RICKEN ACRES

RE: SUB 2003-45 -- Revised One-Step Final Plat of Ricken Acres Addition

STAFF REPORT
(Revised One-Step Final Plat)

CASE NUMBER: SUB 2003-45 -- RICKEN ACRES ADDITION

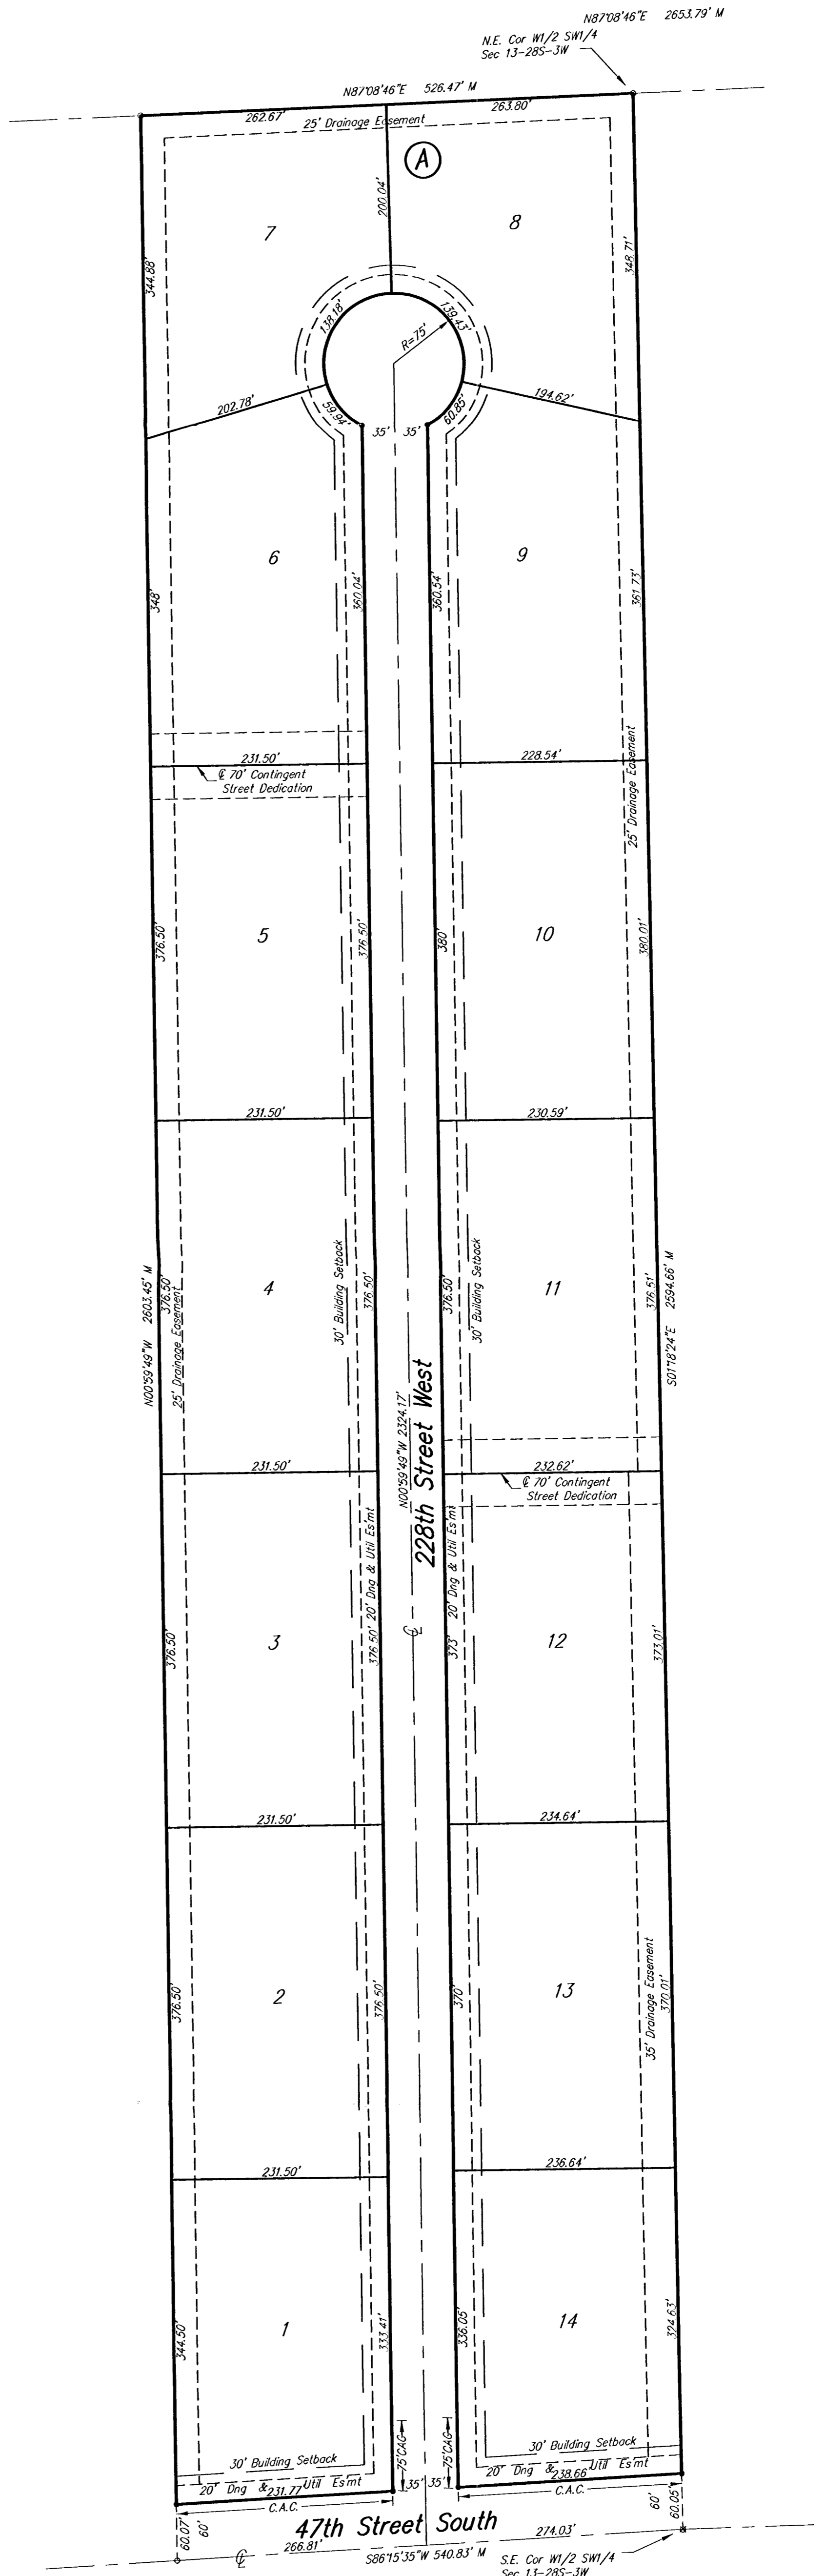
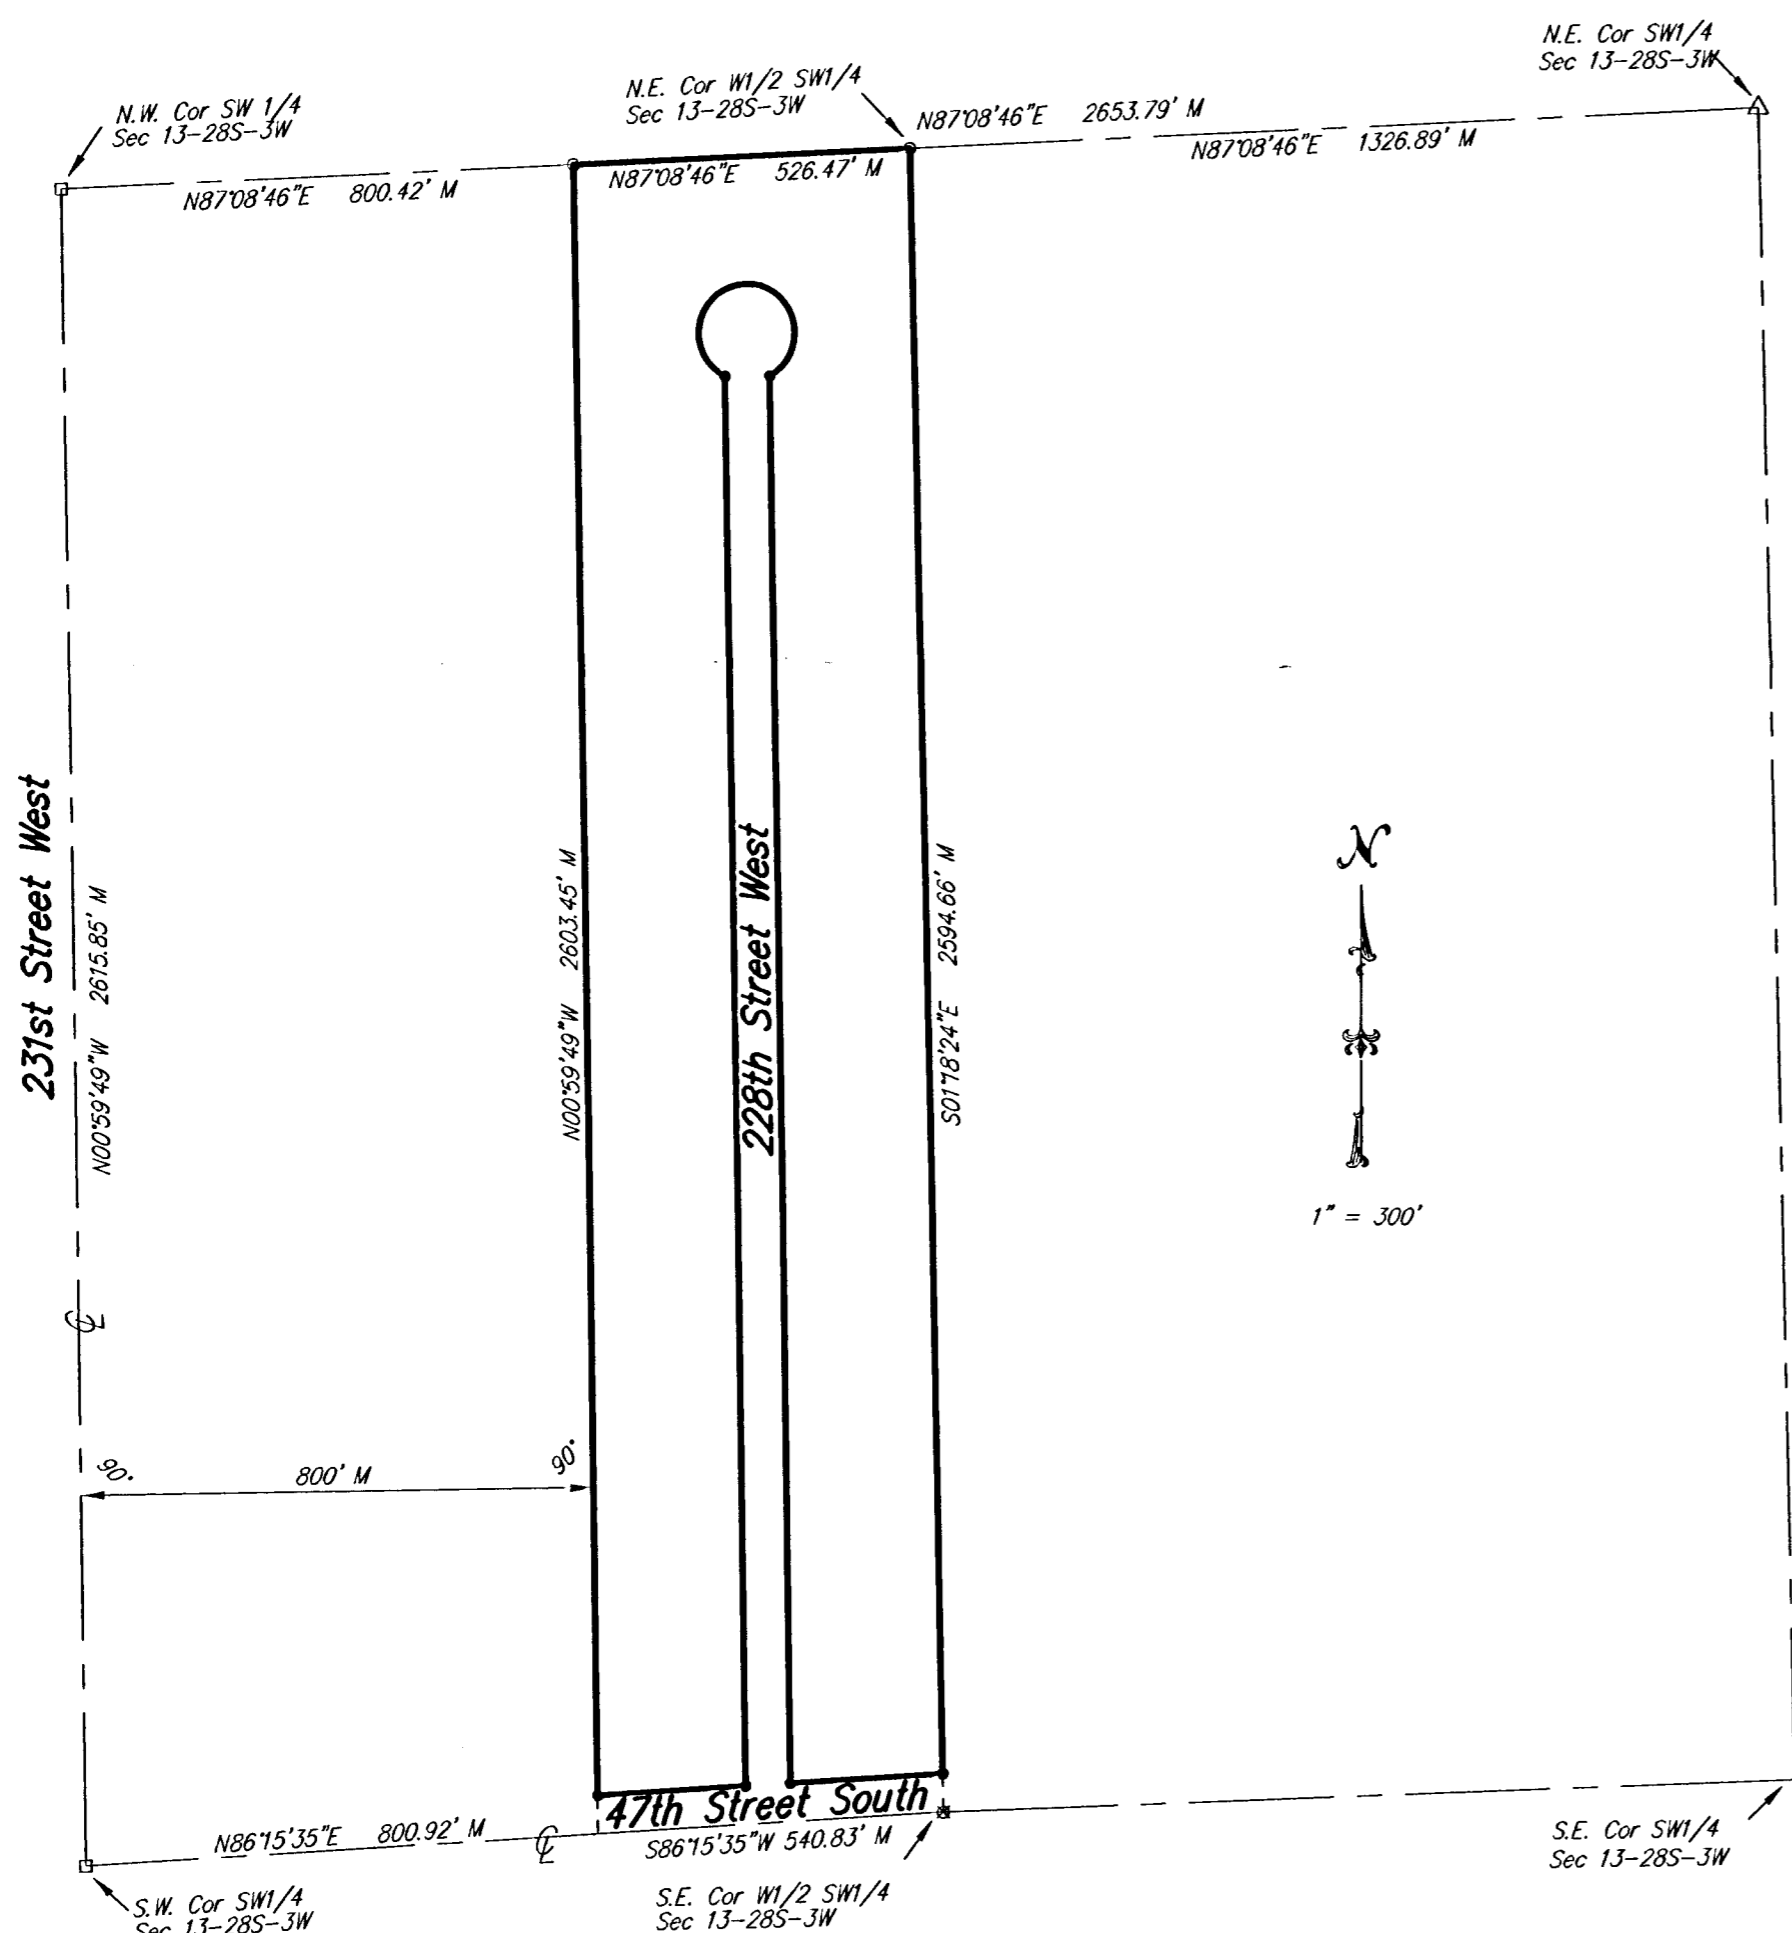
- E. **County Engineering** needs to comment on the status of the applicant's drainage plan. ***A drainage plan is needed that addresses terraces and offsite drainage coming into plat from the east.***

- F. The applicant shall guarantee the installation of the proposed street to the 36-ft rock suburban street standard.
- G. Lots 1, 7, 8 and 14 contain less than the required 2-acre minimum lot size. A zoning adjustment will need to be approved for these lots. This adjustment should be submitted after the MAPC approval.

- I. The Applicant has provided a 70-ft contingent dedication of street right-of-way extending to the east line and west line of the plat in order to provide potential street connections to adjoining properties. MAPD recommends that the contingent street dedication to the west is relocated to the north between Lots 5 and 6.

- J. The MAPC signature block needs to reference "John L. Schlegel, Secretary".
- K. The County Fire Department/GIS needs to comment on the plat's street names. The street name shall be revised to "228th St W.

- M. The plat's text shall include language that a drainage plan has been developed for the plat and that all drainage easements, rights-of-way, or reserves shall remain at established grades or as modified with the approval of the applicable City or County Engineer, and unobstructed to allow for the conveyance of stormwater.
